Ref: FCC Class II Permissive change for FCC ID: **SPYIM0002**
Original Grant Date: 07/28/2016
Applicant: Bitatek Co., Ltd.

This is to request a Class II permissive change for FCC ID: **SPYIM0002**, originally granted on 07/28/2016

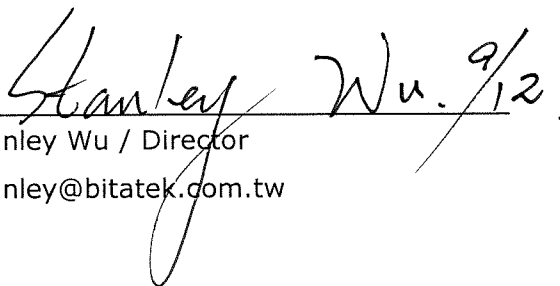
The major change filed under this application is:

1. The subject approved module is being used in a host (Portable category configuration, Brand name/Model: see test report.)
2. The difference compared with the original design is adding 2 antennas to this EUT:

IFA Antenna,

Maximum Gain: 2.0 dBi at 2.4GHz ; 2.9 dBi at 5GHz.
